Lancaster County School District Amendment #1	Solicitation Number	202502	
		Solicitation Issue Date	07/30/24	
		Amendment Issue Date	8/12/24	
		Procurement Officer	Trevor Hammond, NIGP-CPP, CPPB (803) 416-8828	
		E-Mail Address	trevor.hammond@lcsd.k12.sc.us

DESCRIPTION: **Restrooms for BHS & LHS Baseball Fields**

Effective this date, this amendment forms part of the contract documents and modifies the original IFB

DEMOLITION/SITE PLAN

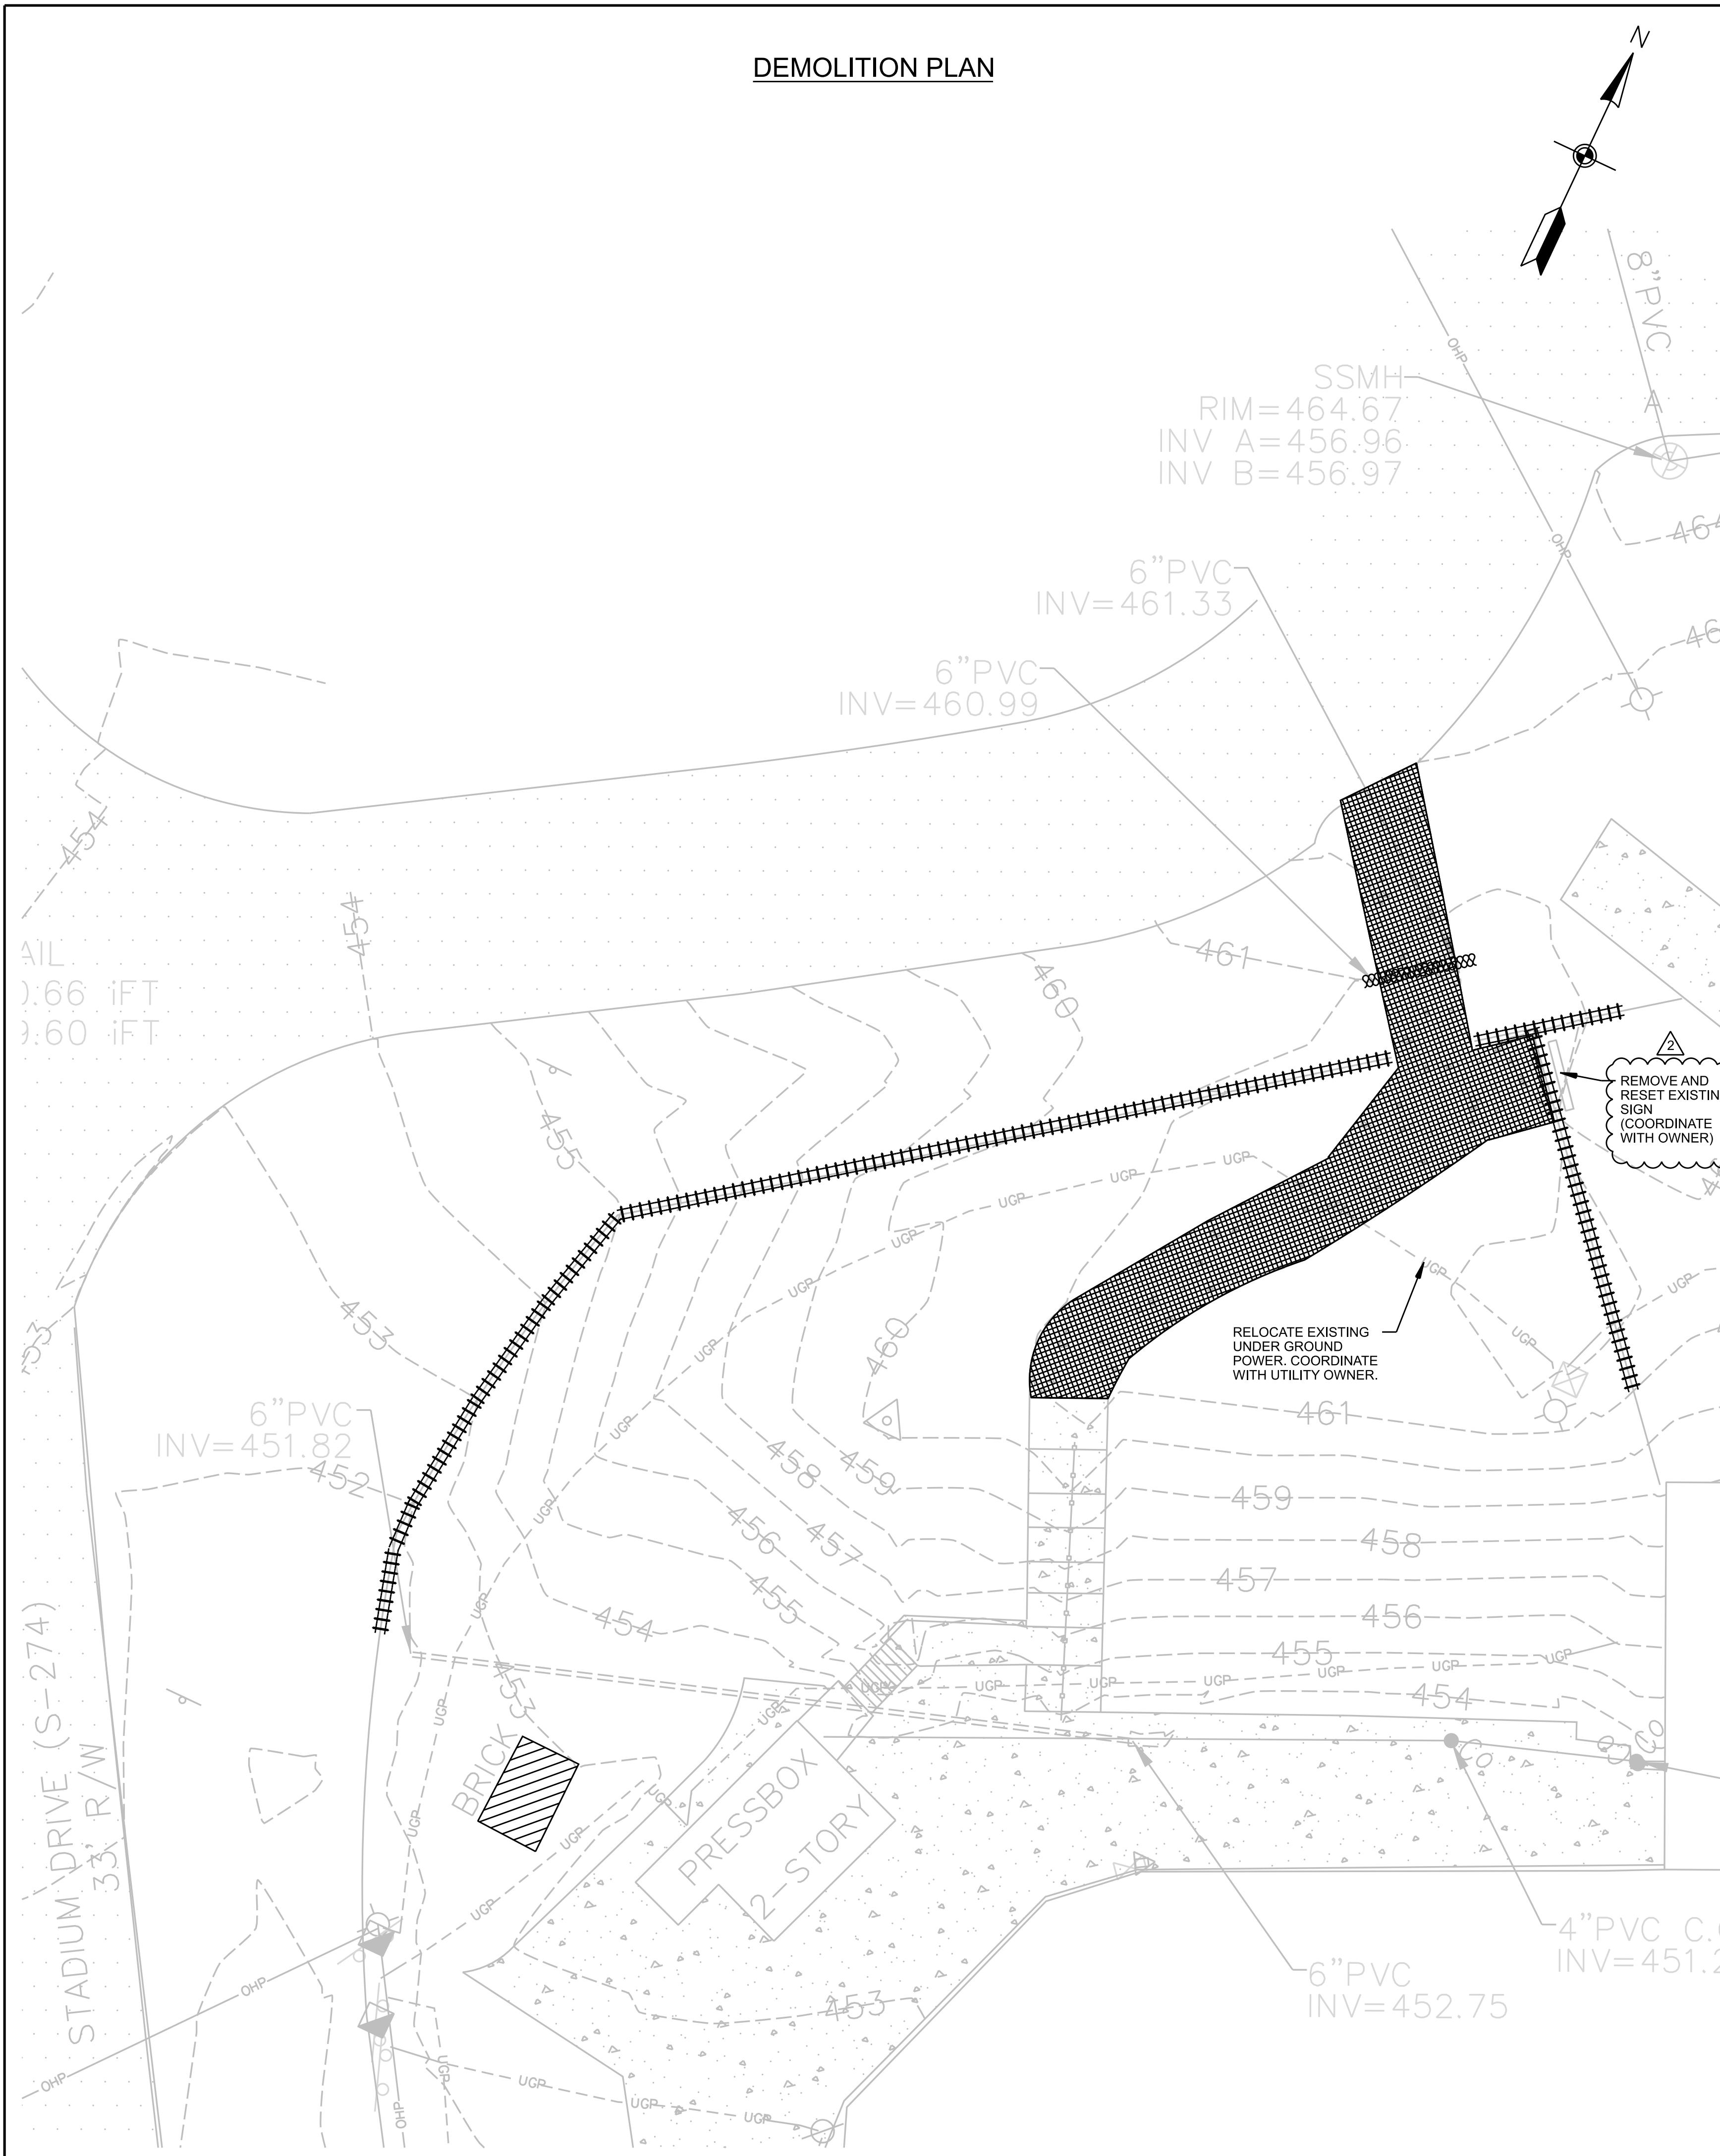
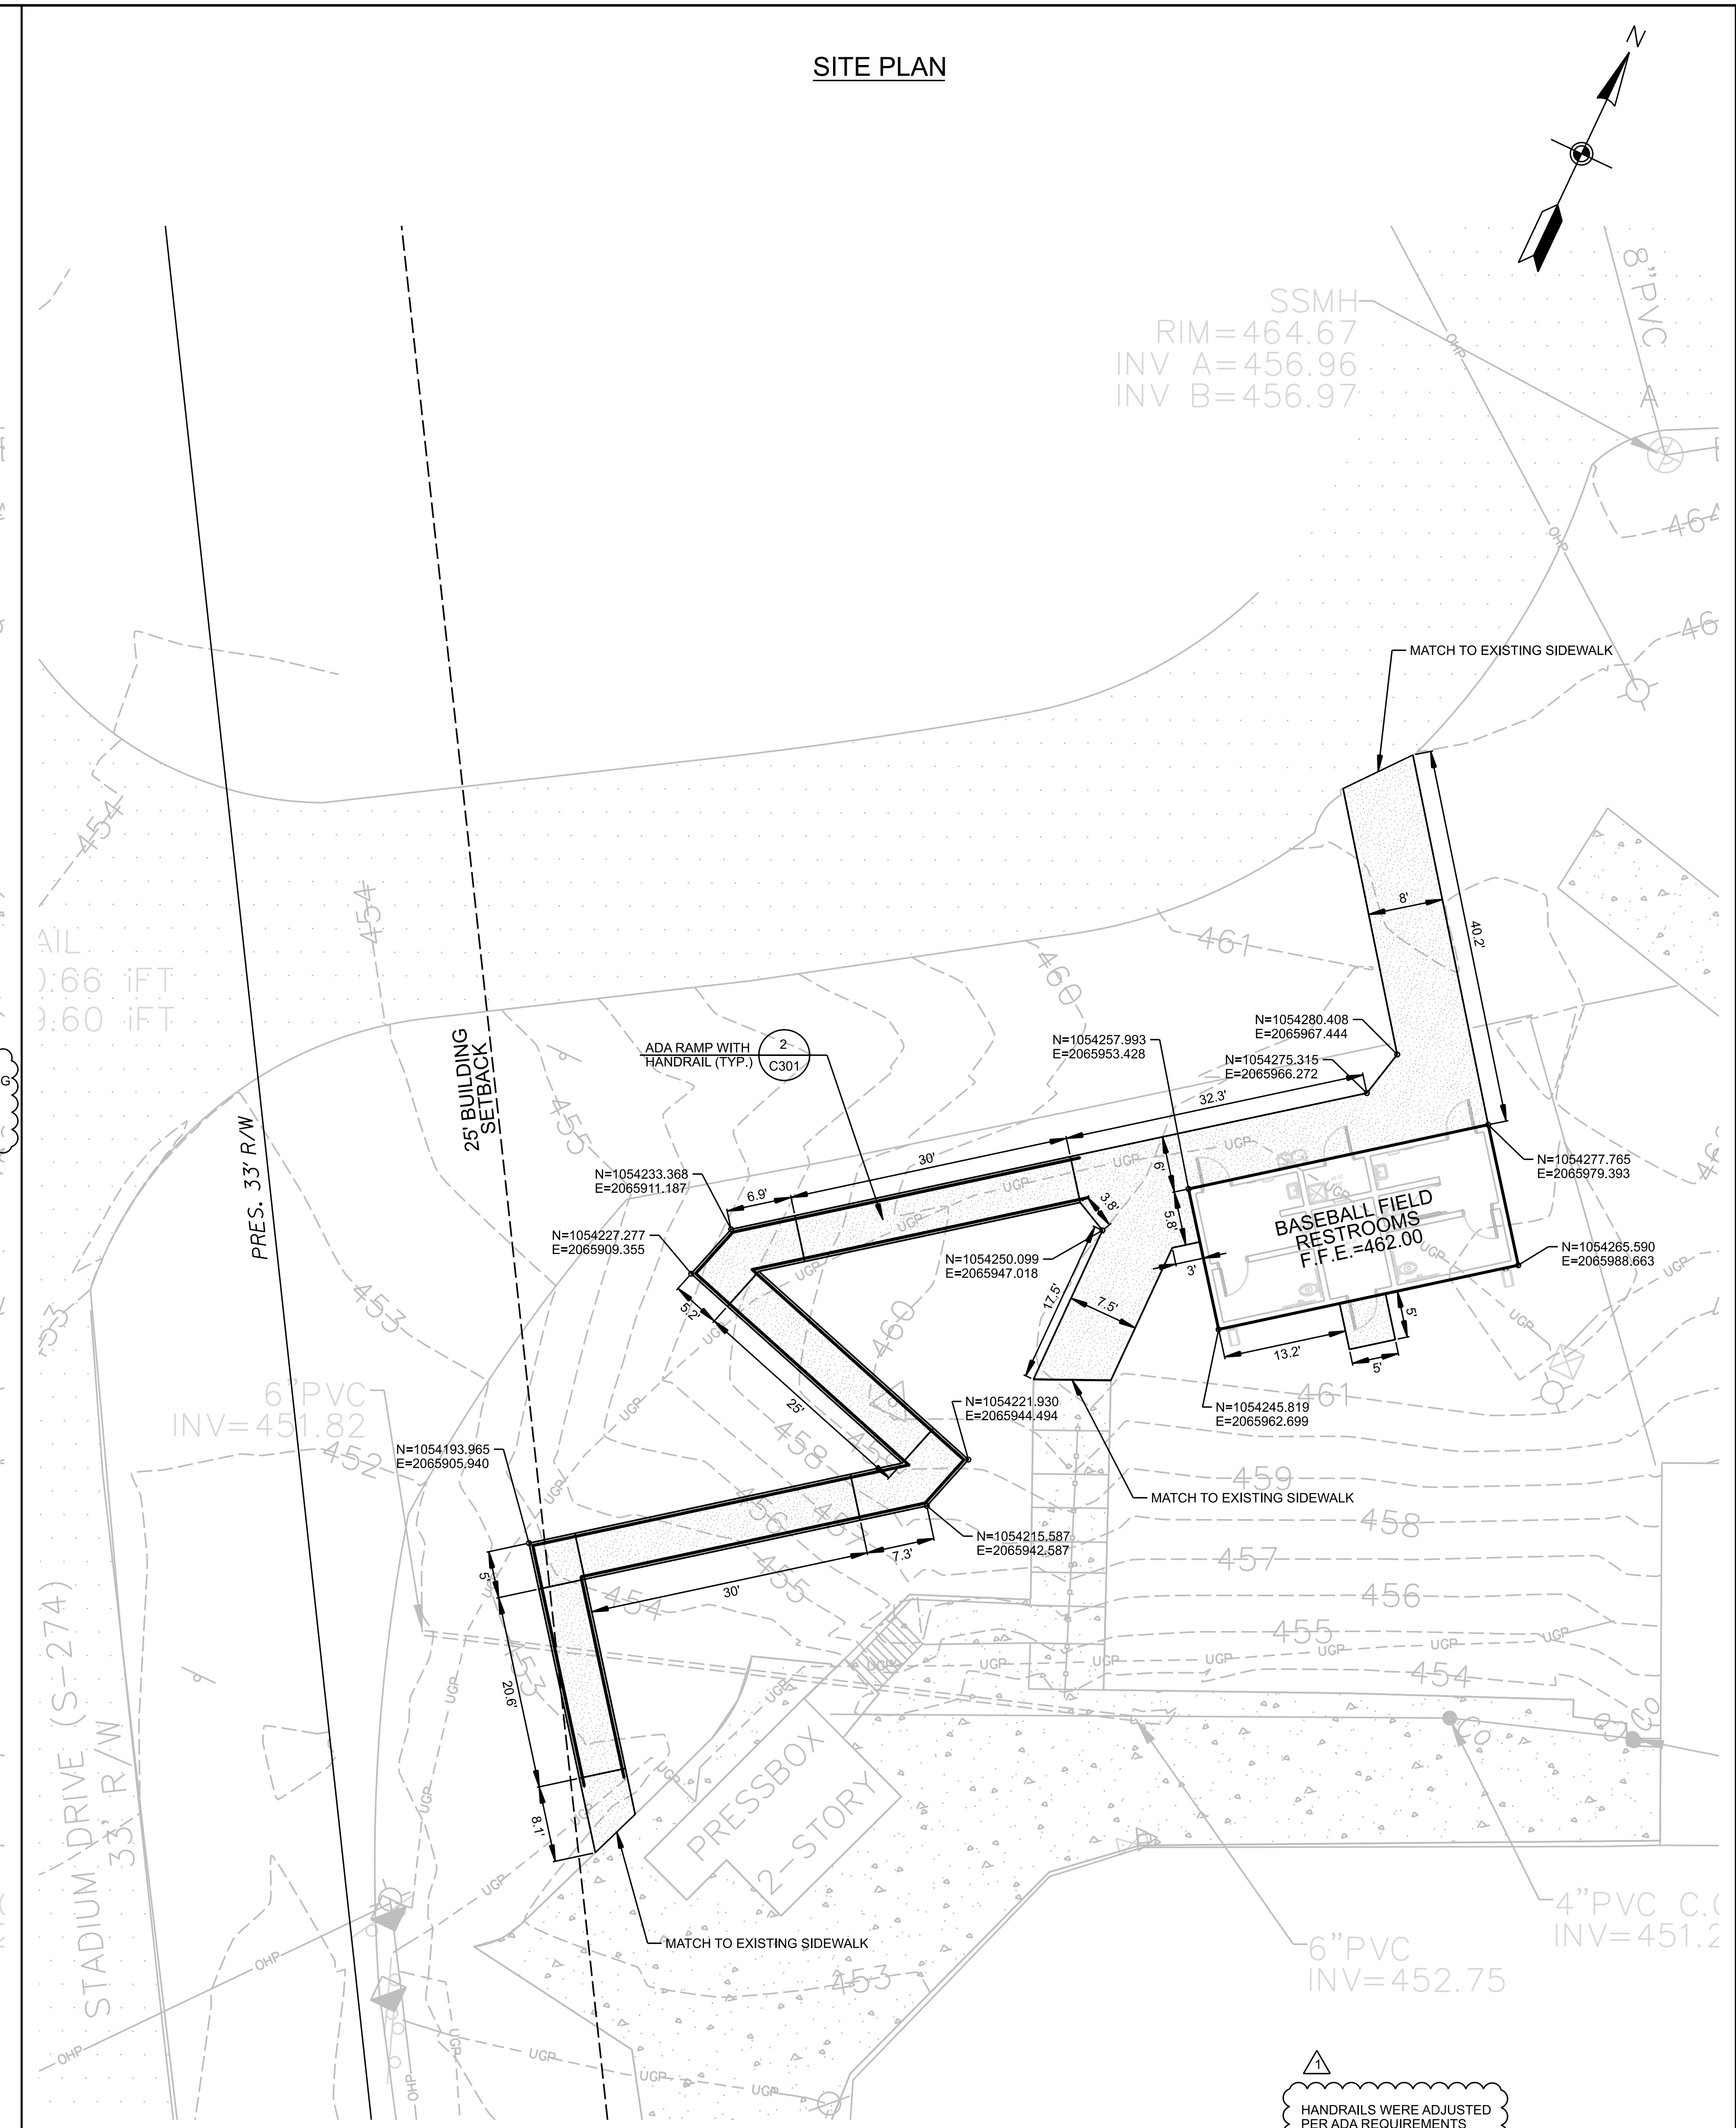
- B. Replace sheet C300 with revised sheet C300 – Demolition/ Site Plan, included in the Attachments.
 1. Revised to reflect the removal and reset of an existing sign.

WATER & SANITARY SEWER SERVICE PLAN

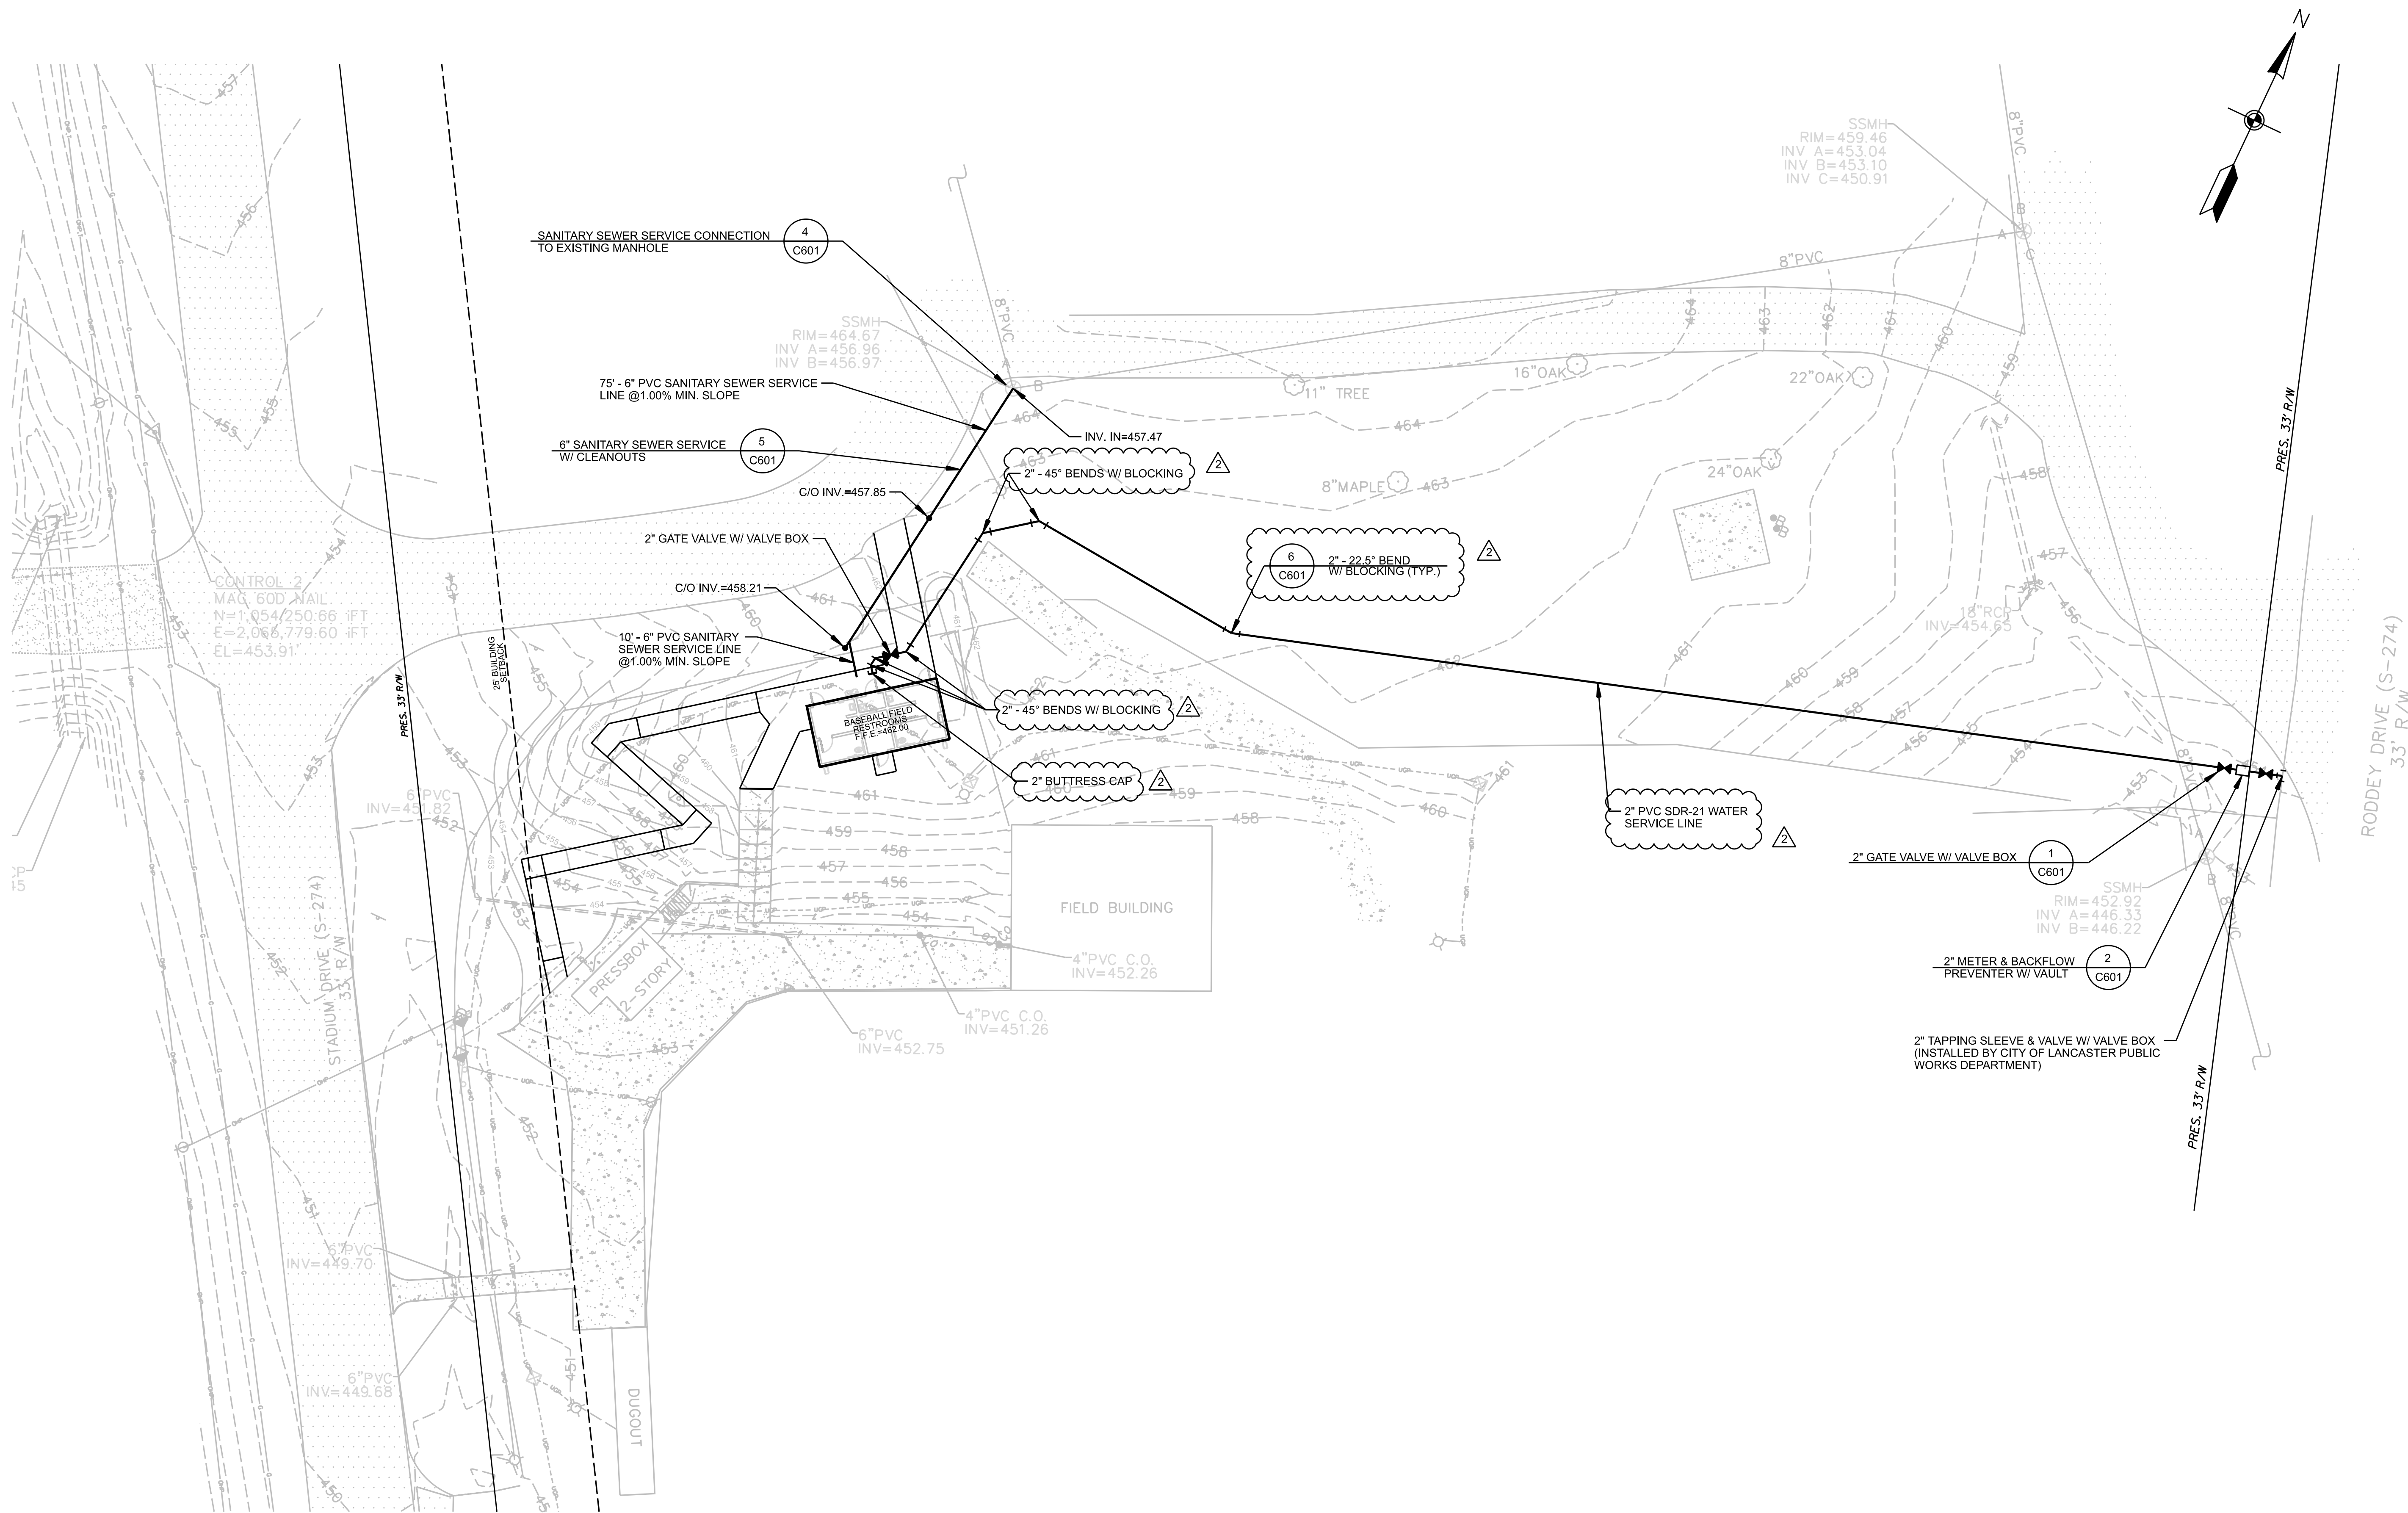
- C. Replace sheet C600 with revised sheet C600 – Water & Sanitary Sewer Plan, included in the Attachments.
 1. 2-inch polyethylene C-901 water service line has been revised to a 2-inch PVC SDR-21 water service line.

2. 2-inch compression fittings have been revised to 2-inch fittings with blocking.
- D. Replace sheet C601 with revised sheet C601 – Water & Sanitary Sewer Details, included in the Attachments.
